TSD Publication 2859 (Vol I)

No. SY/A4
Circulation - All European
Distributors and Retailers
except U.K.

HIGH-SPEED ROUGHNESS AND NOISE

Fig.1 Brake pad anti-rattle springs in position

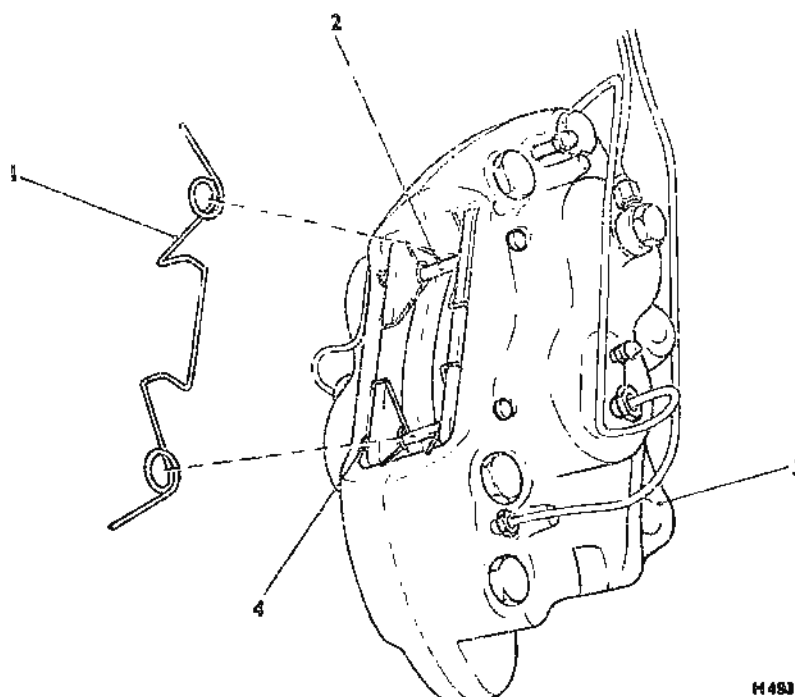
1. Support the rear of the car at the recommended jacking points and remove each road wheel.
2. Remove the securing clip from each pad locating pin and slide the pins outward to disengage one pad.
3. Position one anti-rattle spring as shown in Figure 1 and enter the two pad locating pins into the spring coils (i.e. one pin into each coil).
4. Push the pins inward and through the coils of the second anti-rattle spring positioned by the opposite brake pad as shown in Figure 1.
5. Guide the pins further so that they pass through the brake pad back plate and into the respective holes in the brake caliper body. Fit the securing clips into each locating pin.

Note It is most important that the springs are fitted only in the positions indicated in Figure 1 and not the reverse way round.

Fig.2 Method of fitting fulcrum pin retaining clip

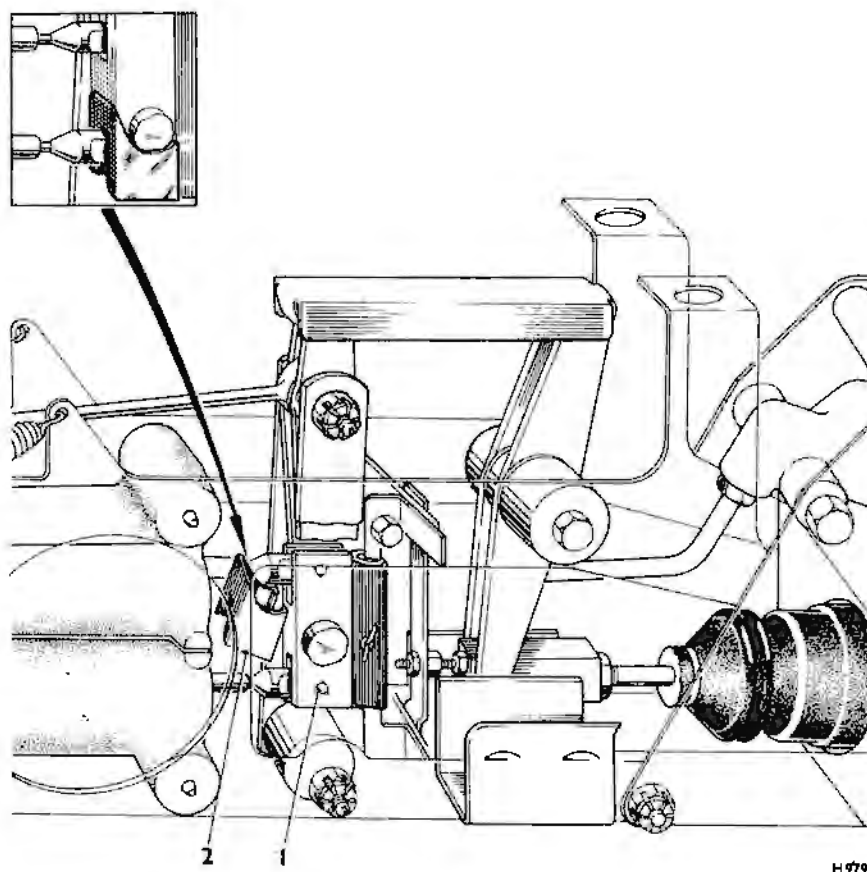
The modifications which have been devised are in the form of three clips which can be fitted in position on the car in a matter of minutes and once in position they will retain the brake linkage pins even if they become slack. These clips will only be fitted retrospectively on cars in service and will not be fitted on cars produced after car number 3384.

1. Place the car on a ramp or over a pit.
2. Remove the brake actuation mechanism undertray.
3. Spring the three retaining clips into position as shown in Figures 1 and 2. When the upper clip is in position the tang at its forward end should be bent under the link as shown in the inset in Figure 1.

FIG.1 Front Suspension Damper Arrangement - Earlier Type

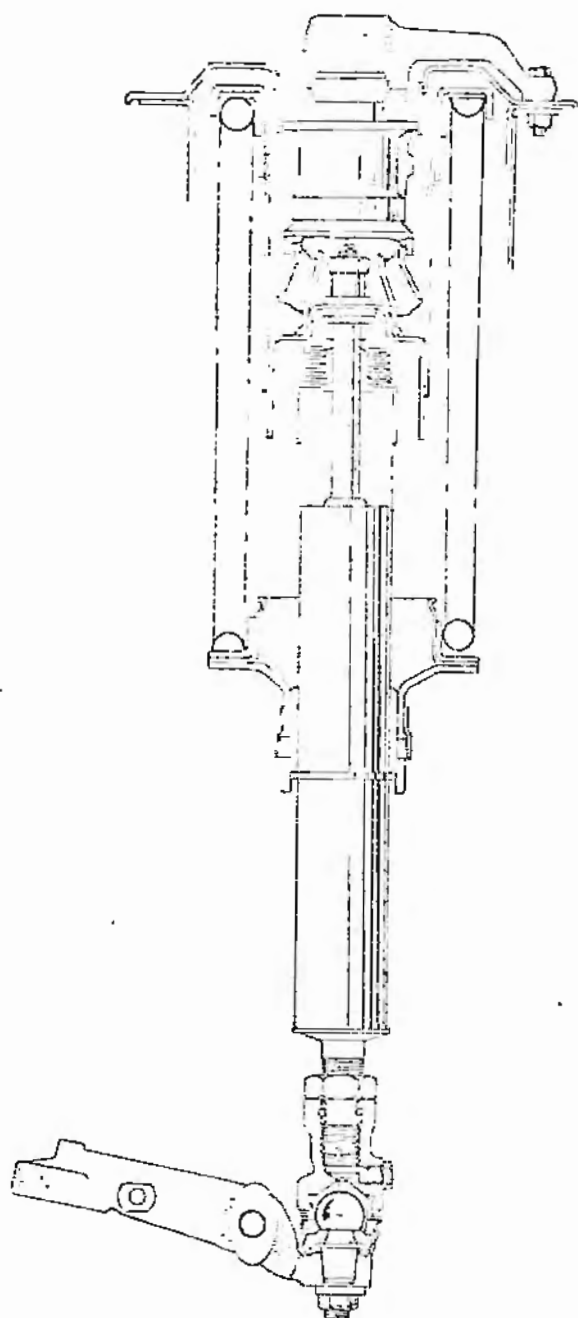
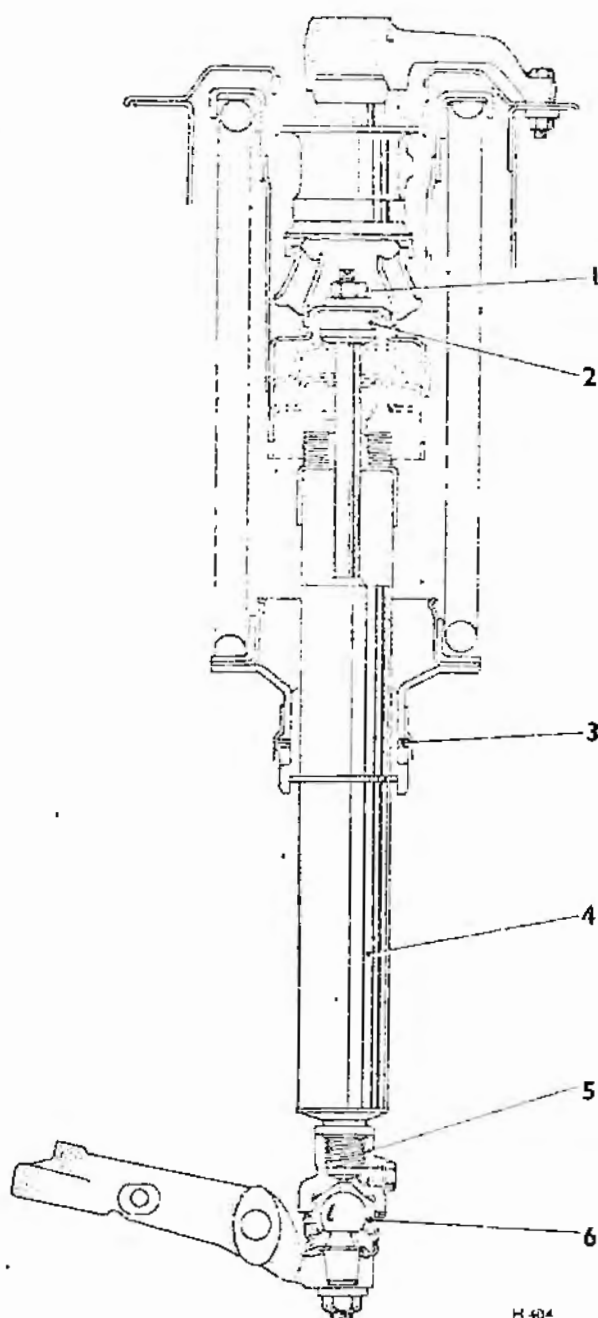
The front shock damper arrangement shown in Figure 1 is common to production cars built prior to the following car numbers - SBH 1433 and CRX 1583.

The front shock damper arrangement shown in Figure 2 is common to cars produced after the foregoing car numbers with the exception of the following cars which have the arrangement shown in Figure 1.

The arrangement shown in Figure 1 provides a means of fine adjustment which permits 0.46 in. (11,51 mm.) alteration to the car front height. This adjustment is described in Section H5, page H36 of the Workshop Manual.

The arrangement shown in Figure 2 which supersedes the Figure 1 dispenses with the fine screwed adjustment. However, fine adjustment can still be achieved by utilising a new packing piece which is 0.064 in. (1.59 mm.) thick. It is permissible to position a maximum of six of these packings, if required, with the existing thicker packings beneath each front spring seat.

To determine which arrangement is fitted to a particular car, a visual check at the lower ball joint housing will suffice. If there is a lock nut present above the ball joint housing next to the shock damper casing, then the arrangement is the earlier type as shown in Figure 1.

The absence of a lock nut denotes the current arrangement shown in Figure 2 which means that no screwed adjustment should be attempted when setting the car front height.

Fig.2 Showing plunger
fitted to engaging
lever

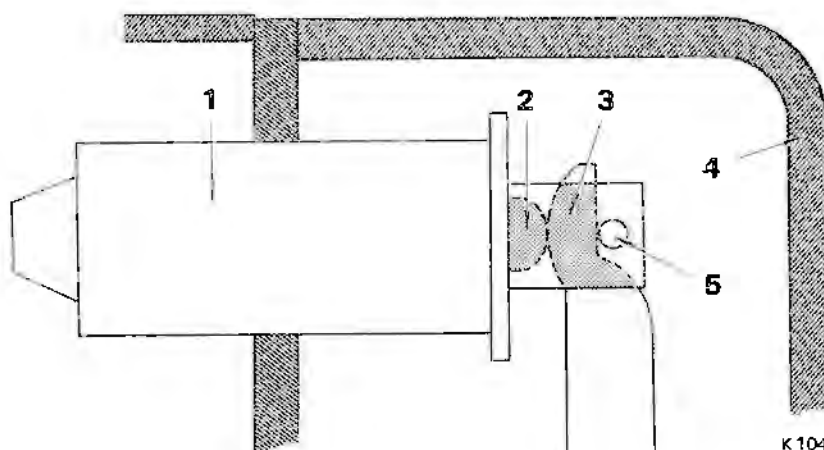
4. Push a clean piece of cloth into the solenoid mounting boss such that the engaging lever will be protected from filings.
5. Using a 0.250 in. (6,40 mm.) round file, cut a slot 0.250 in. (6,40 mm.) in depth across the solenoid mounting face, as shown in Figure 1.
6. Remove the cloth from the mounting boss and ensure that no filings have entered the boss.
7. Clean the solenoid plunger and fit it to the engaging lever ensuring that the lever is gripped between the bar and the spring loaded pin of the plunger, as shown in Figure 2.
8. Fit the new solenoid provided to the starter motor, such that the blade terminal of the solenoid is adjacent to the starter motor casing.
9. Fit the new feed strap between the motor terminal post and the nearest solenoid terminal, tightening the nuts to 20 lb.in. (0,23 kgm.) only.

Fig. 1 - Position of spacer

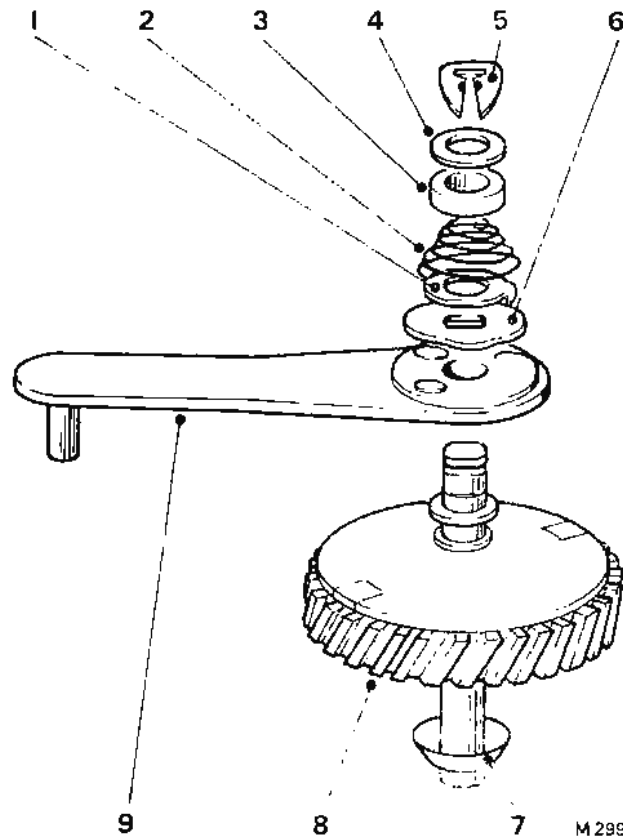
However, it is possible to overcome this extra friction by increasing the force applied by the spring to the wave washer of the anti-streak mechanism. This is achieved by fitting a packing piece between the top of the spring and the existing washer as shown in Figure 1.

Fig.1 Lockplate in fitted position

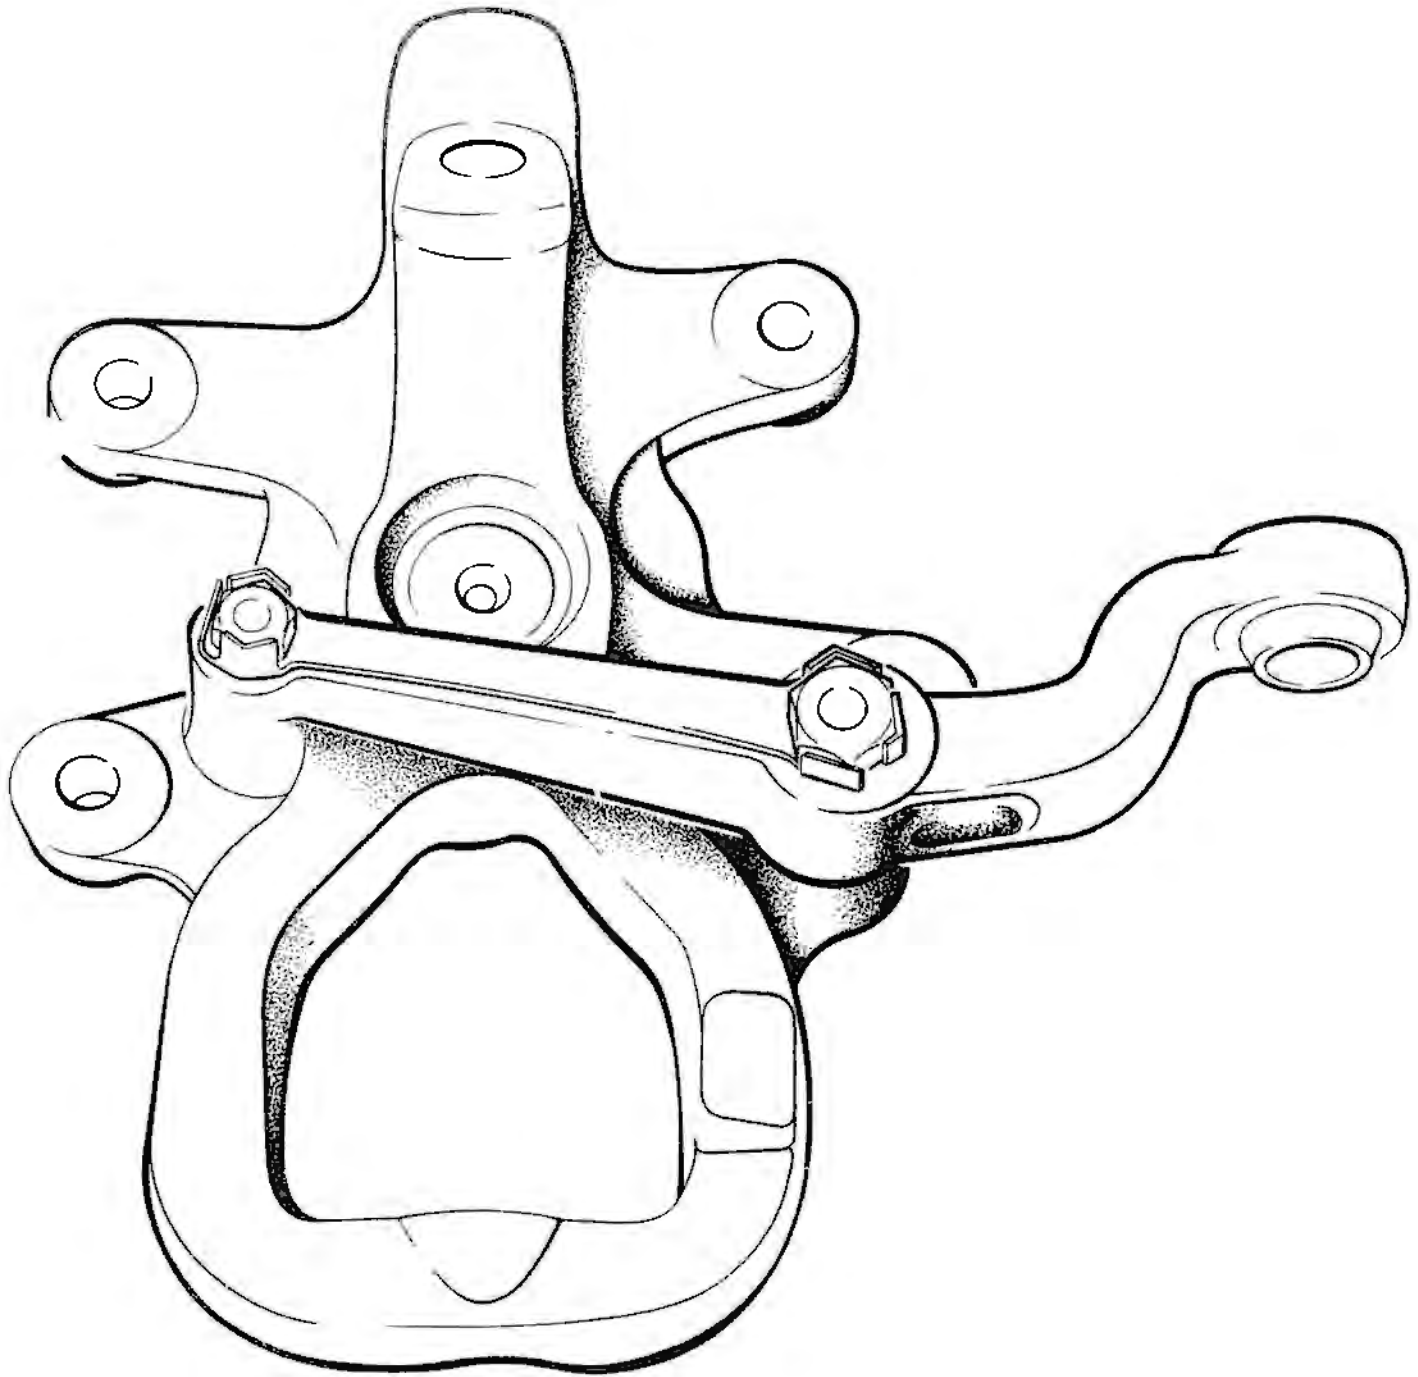
The modification consists of a stainless steel lock plate fitted under the heads of the two setscrews as shown in Fig. 1.

Fig.1 Inner sill L.H. - Drilling dimensions
(R.H. symmetrically opposite)

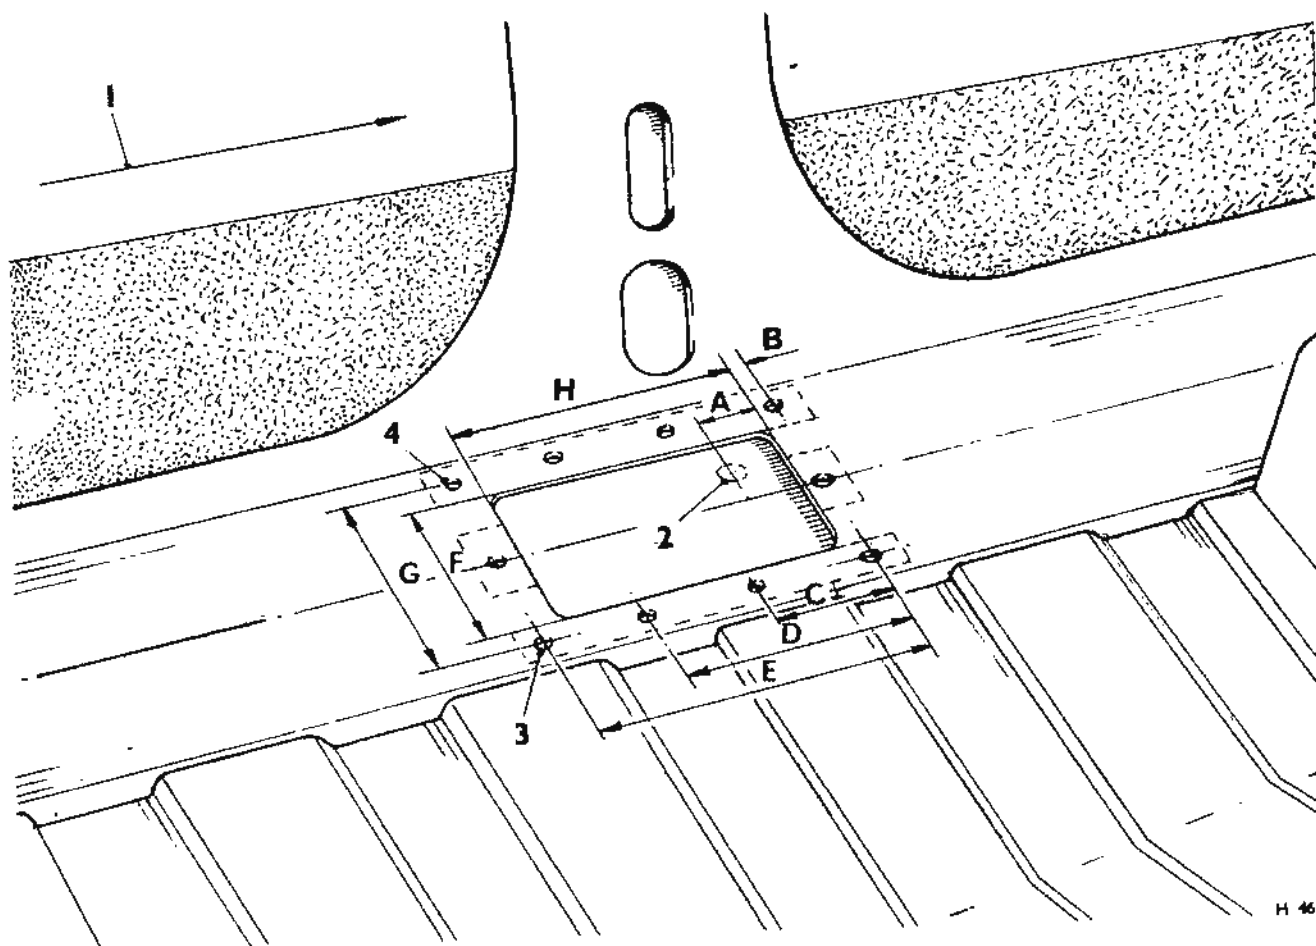
Working to the dimensions given in Figure 1, mark out the section of sill to be removed, also the holes to be drilled. Note that these dimensions are taken from the centre of the existing safety belt mounting point (see 2, Fig.1).
